HILL VALLEY - PHASE 2B

CITY PROJECT NO. 15860
CONTRACT NO. 9680

REVISION 1 - 04/29/26

REVISION 2 - 05/28/26

15860	15860	15860	15860
MADISON, WI	9680	15860	15860
CONTRACT NO. 15860		P-12	
PLAN & PROFILE - S PLEASANT VIEW ROAD (ASPHALT PATH)		HILL VALLEY - PHASE 2B	
M:\DESIGN\Projects\15860\CAD\Streets\15860EN-PrP.dwg		CITY OF MADISON WISCONSIN	
15860		15860	
P-12		P-12

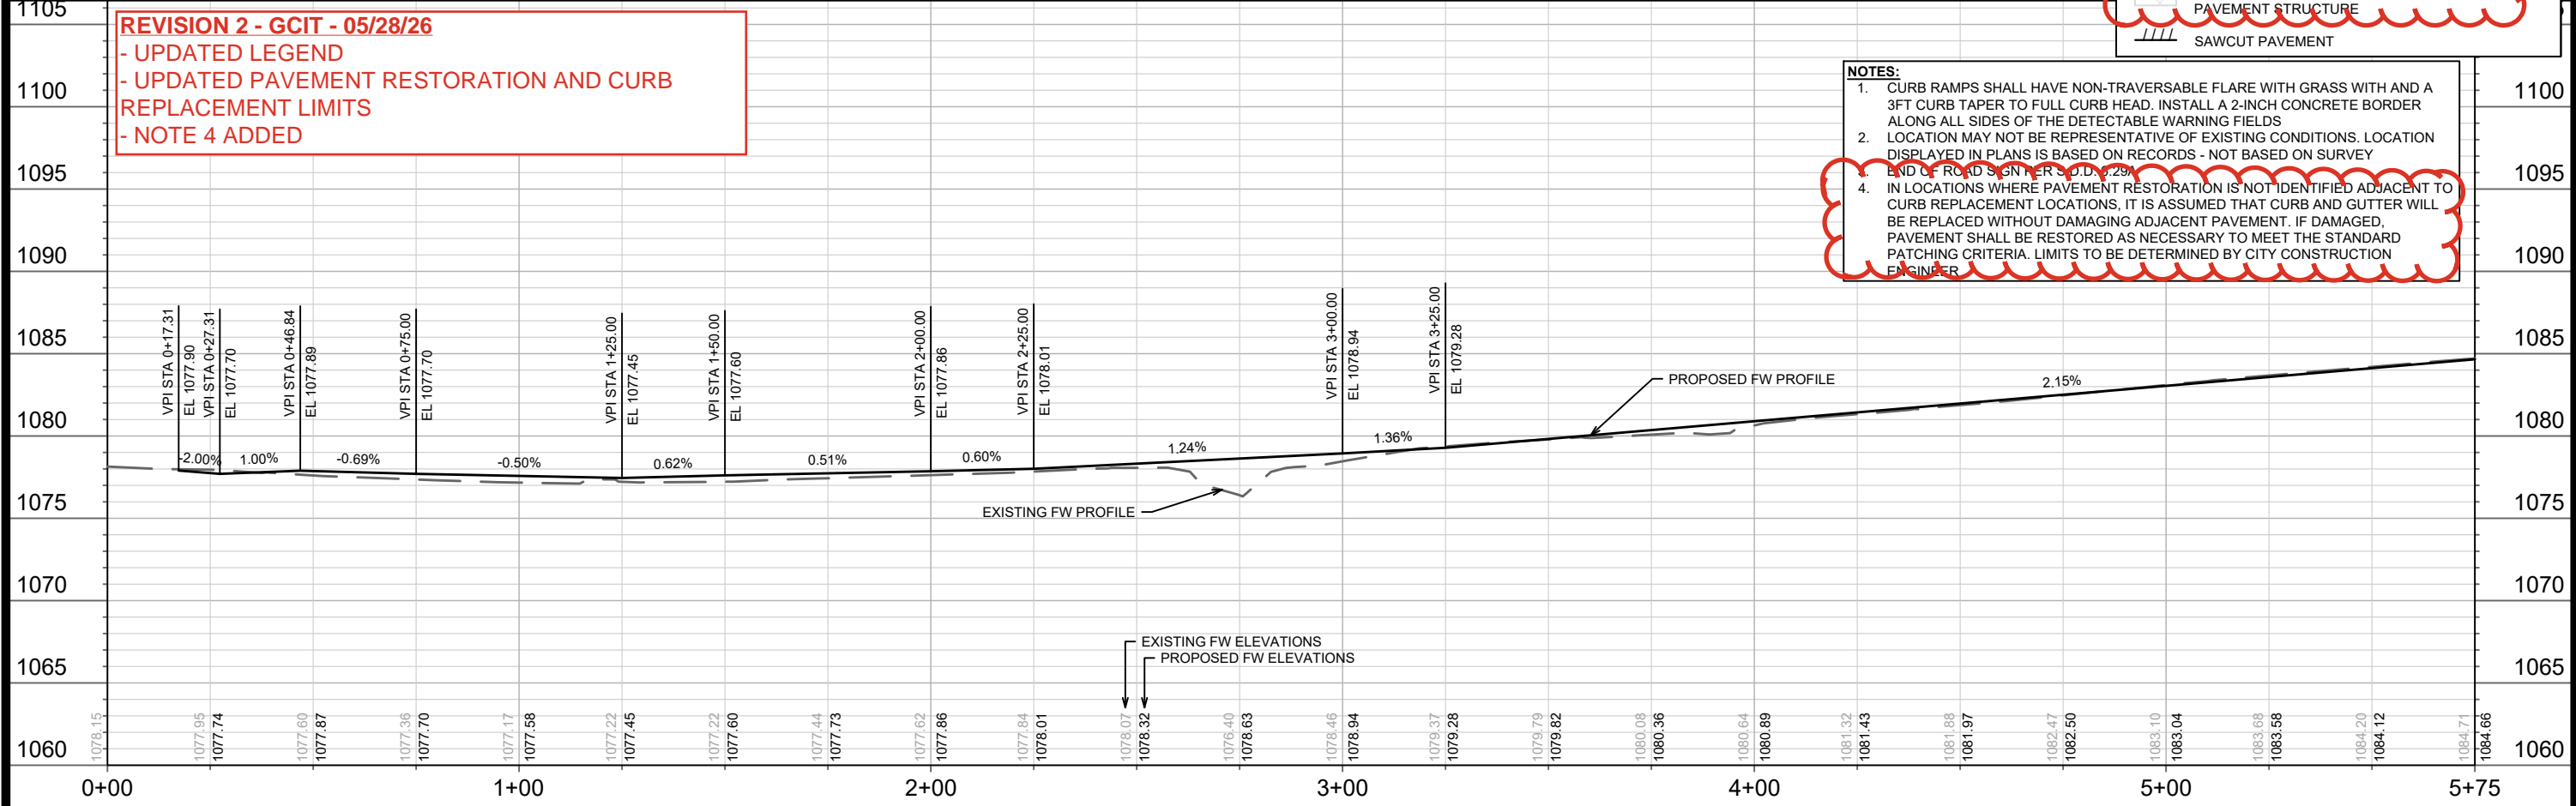
REVISION 2 - GCIT - 05/28/26
 - UPDATED LEGEND
 - UPDATED PAVEMENT RESTORATION AND CURB REPLACEMENT LIMITS
 - NOTE 4 ADDED

15860
 U-1

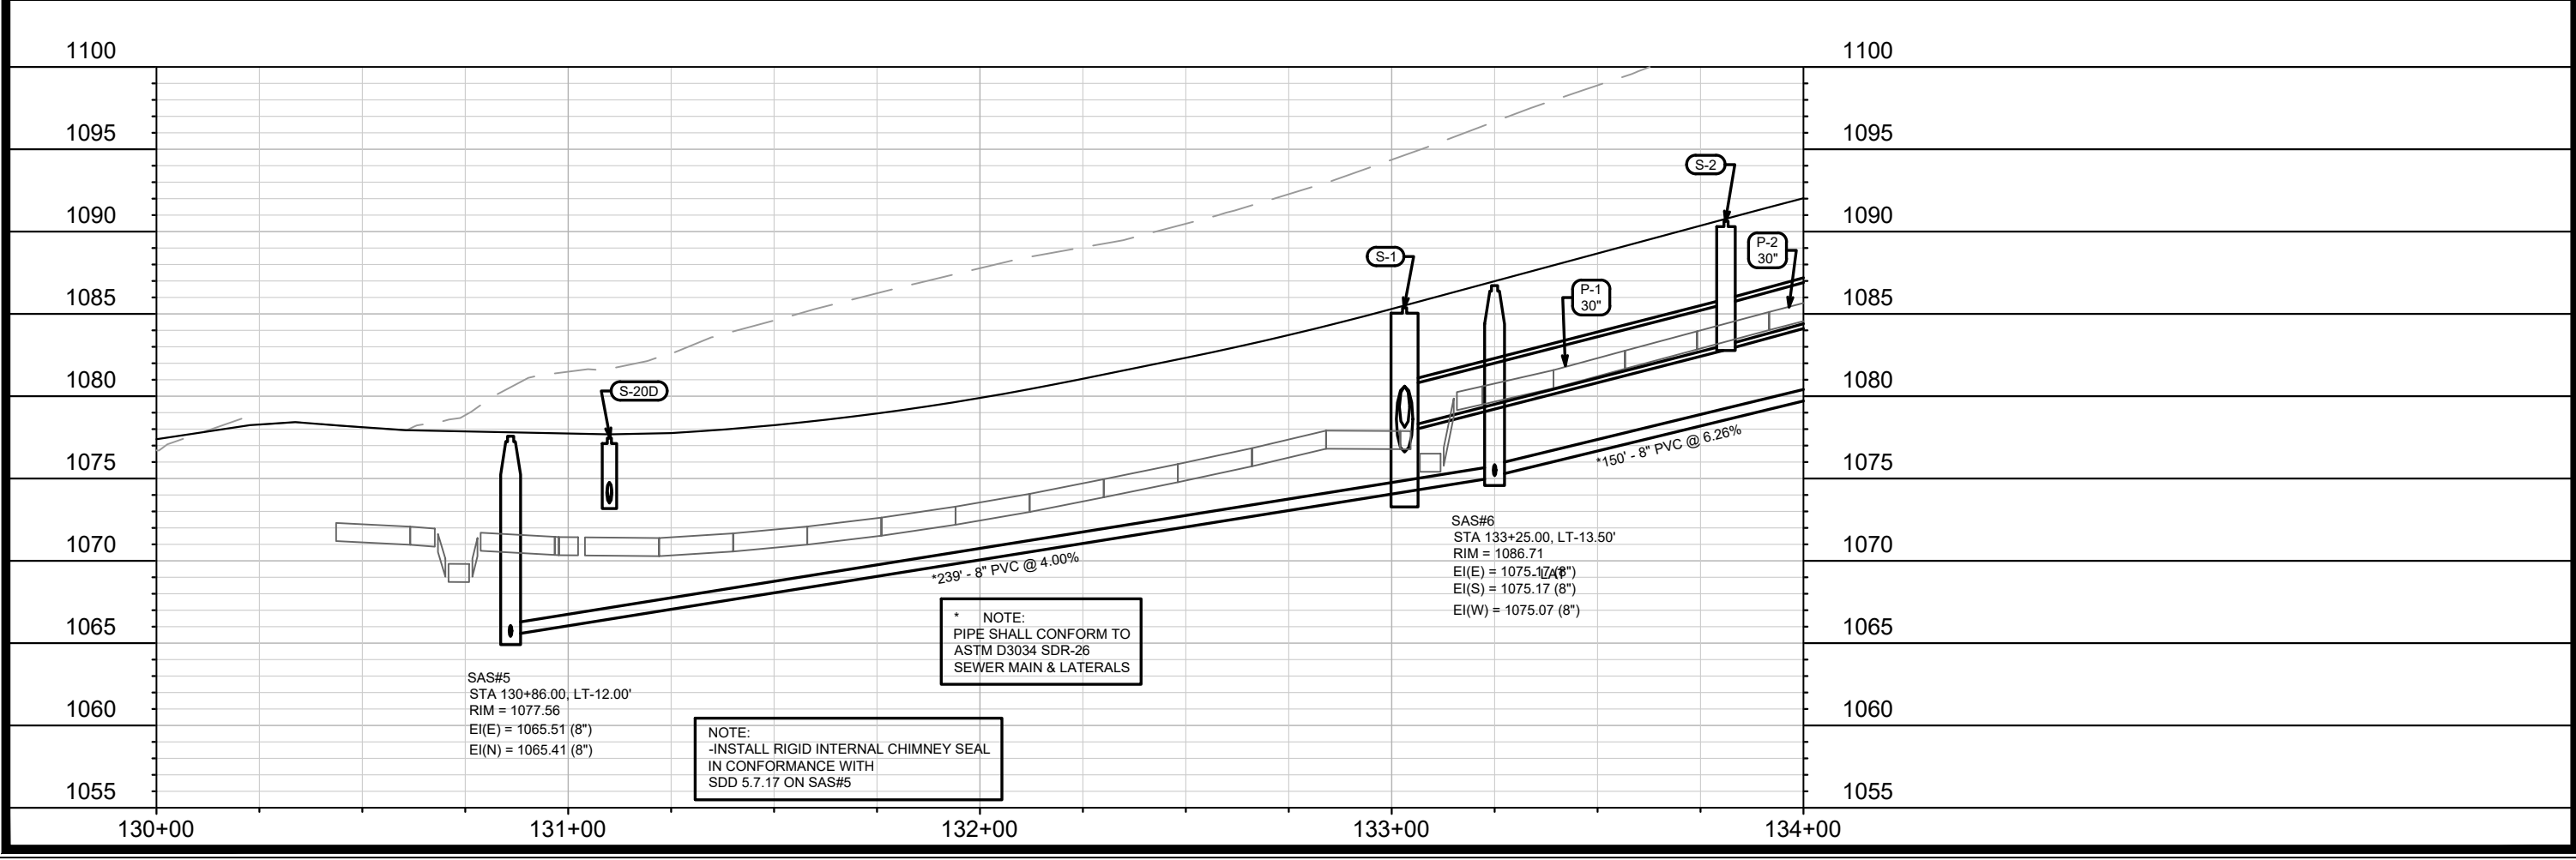
REVISED 5/28/2026 EEA
 -Deleted structure S-20 & pipes P-20 & P-20D on Pleasant View Rd.
 -Added pipes P-30C, P-20X, P-20Y
 -Added structure S-20X
 -Revised inverts on structures from S-20A to S-20D

15860
 U-2

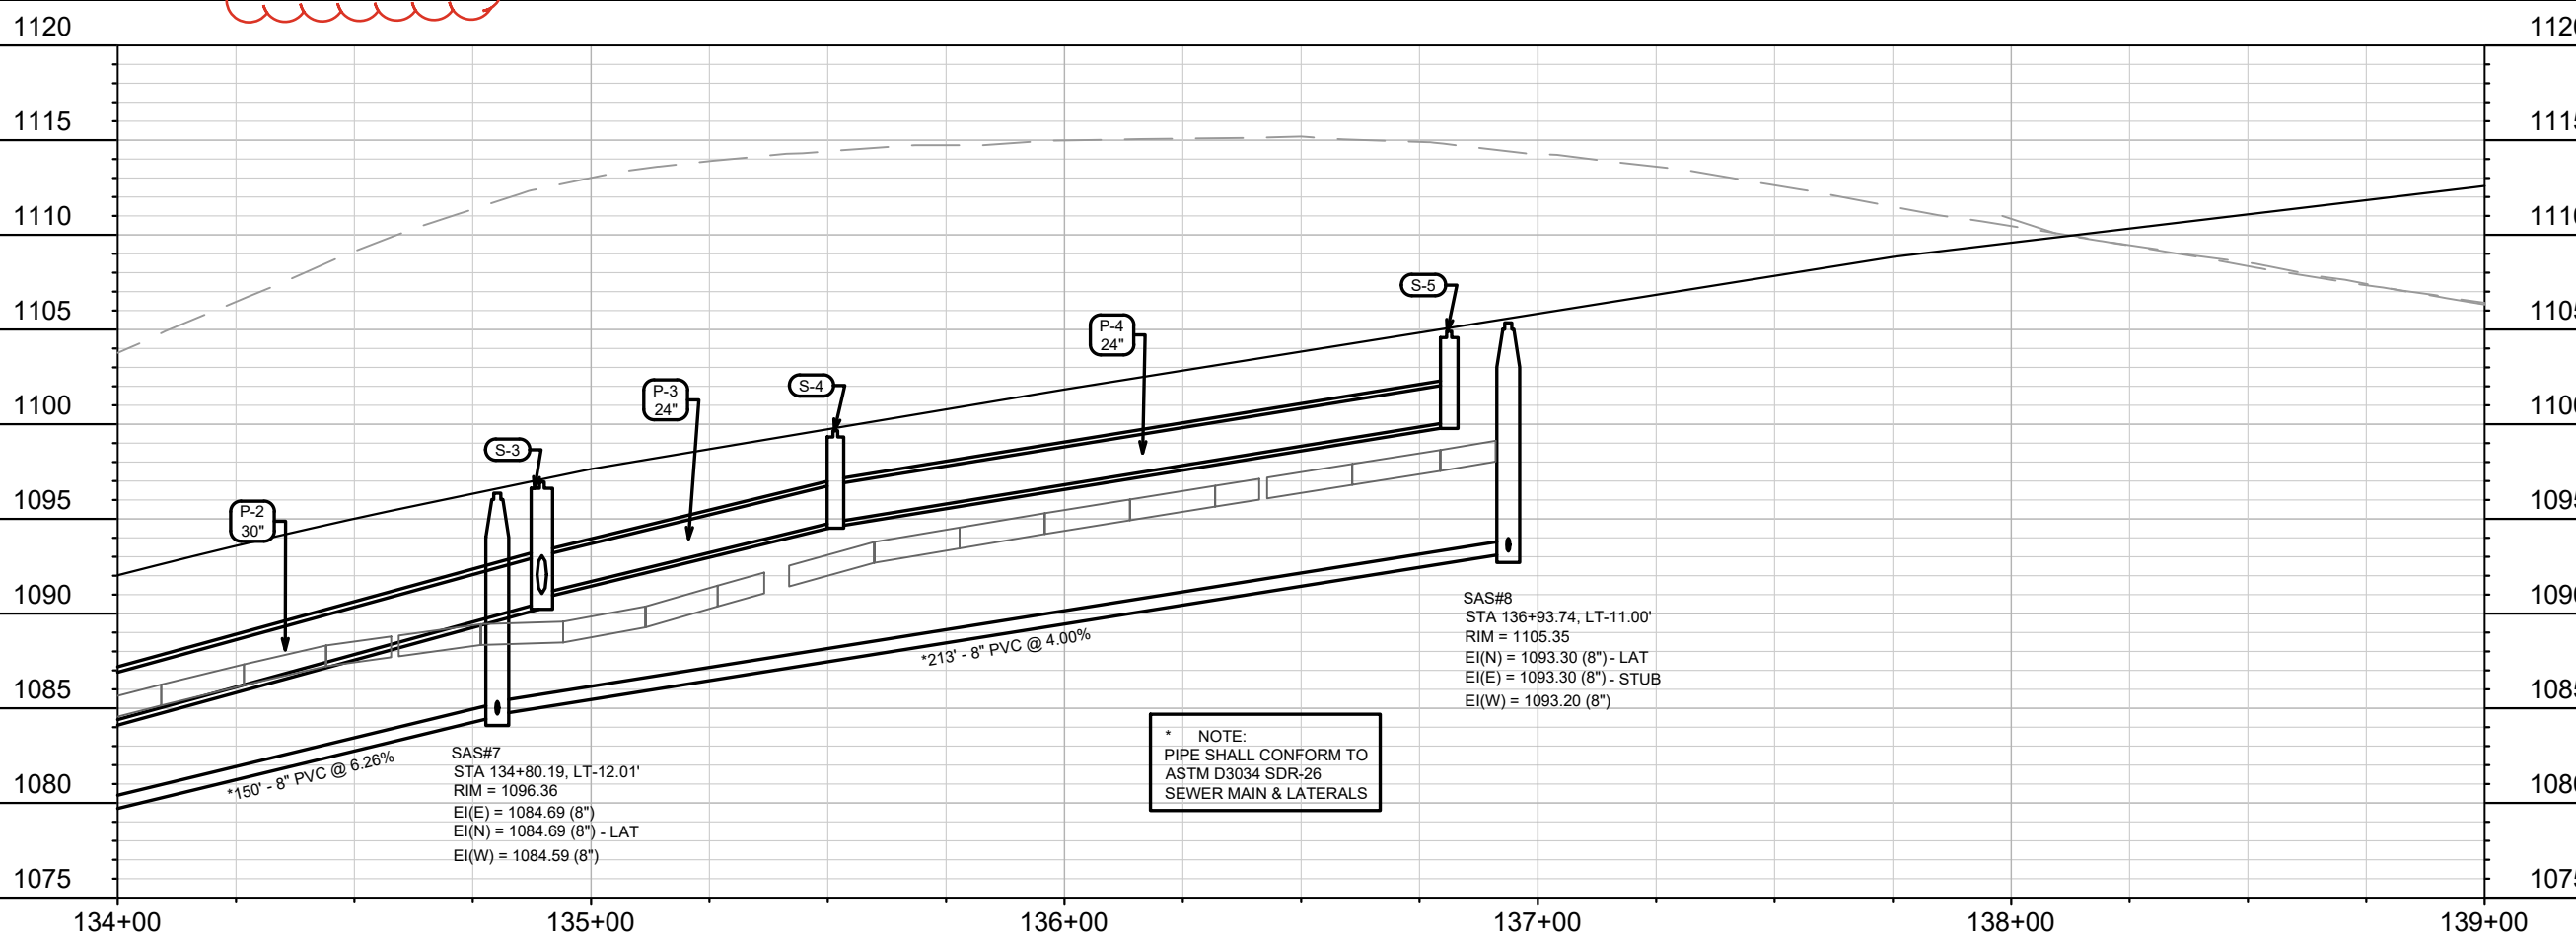
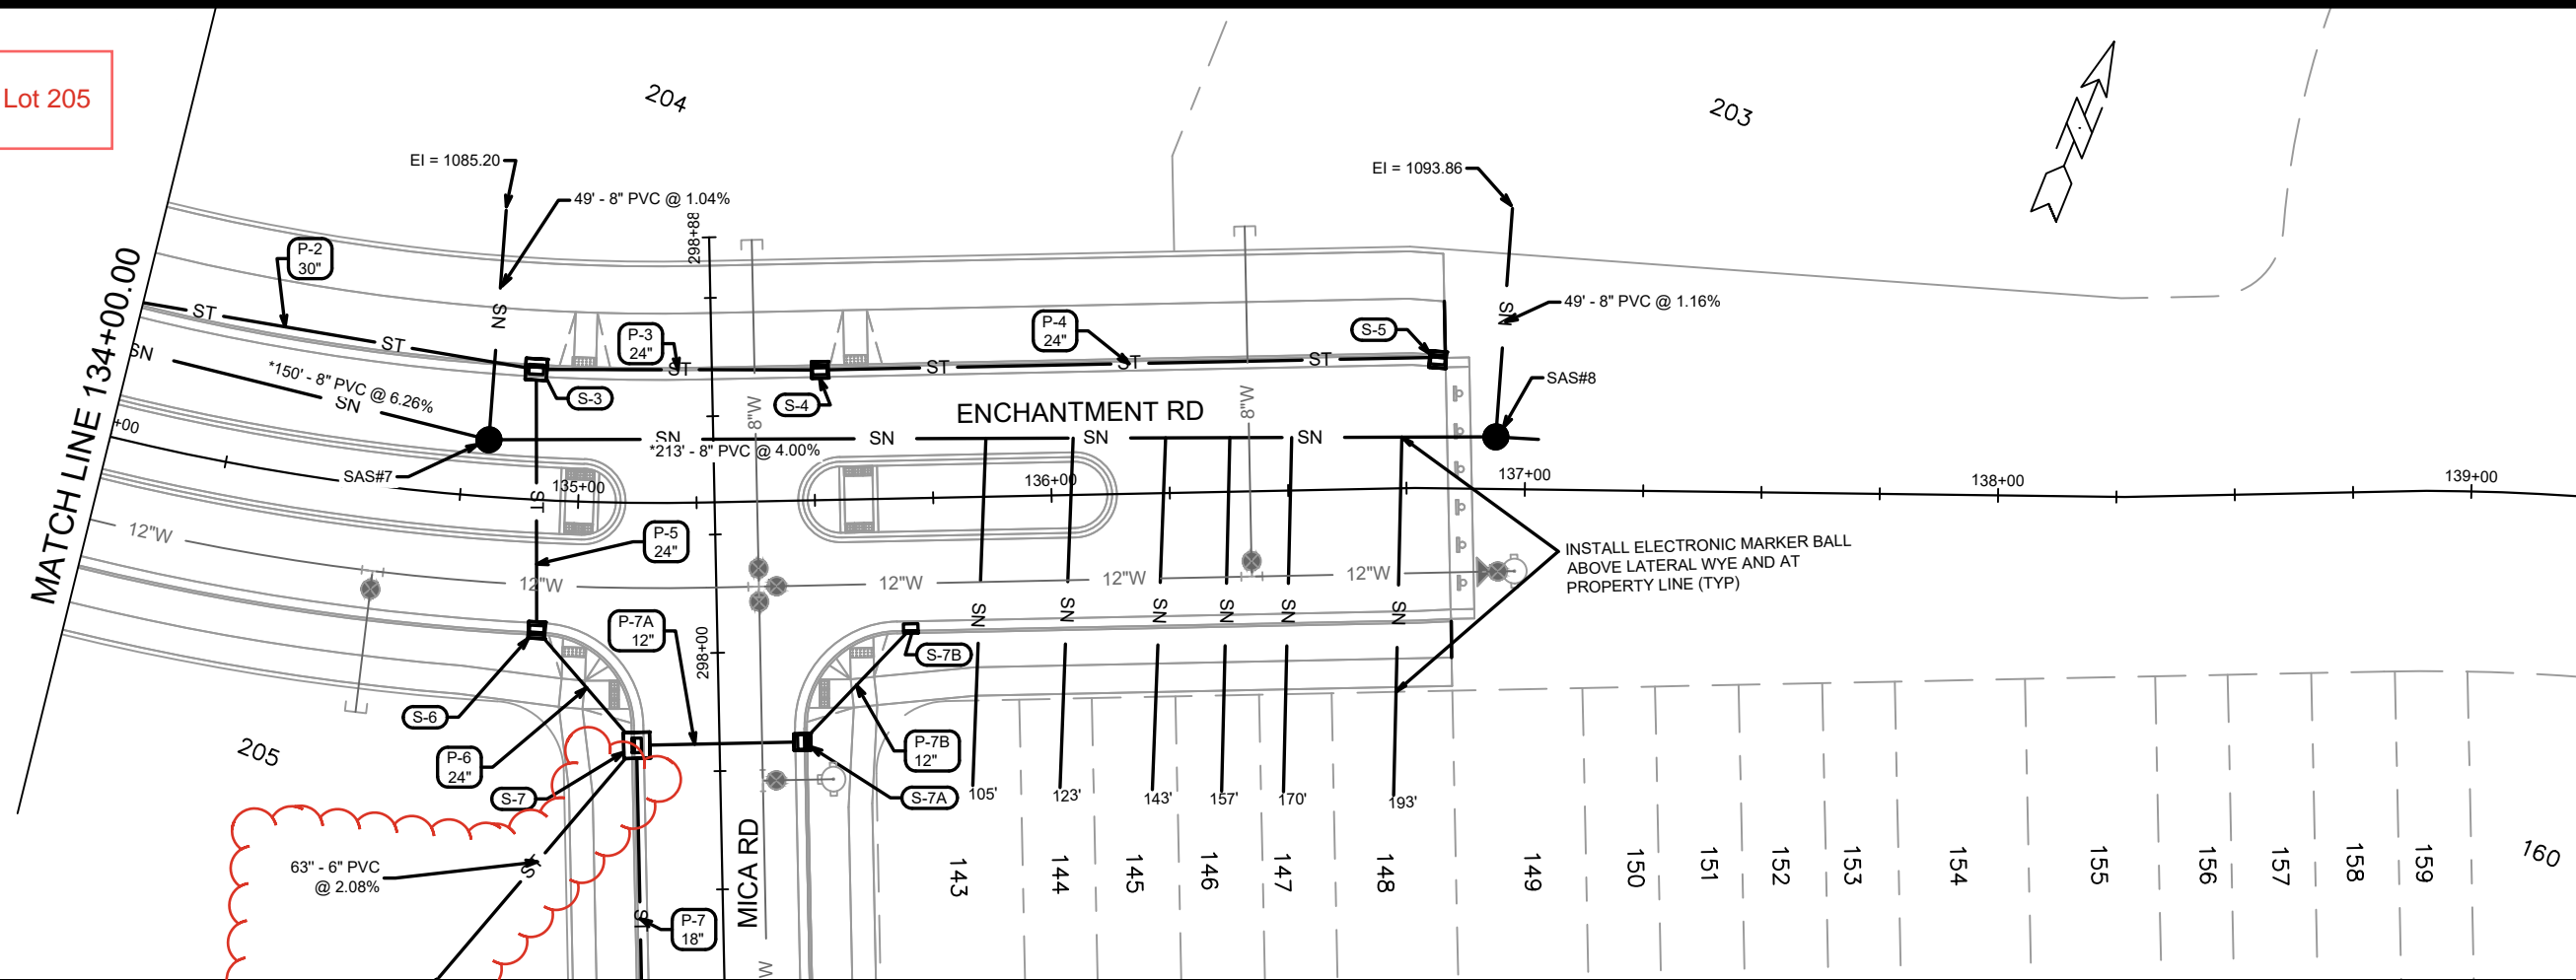
REVISED 5/28/2026 EEA
 -Added pvt storm lateral to Lot 205
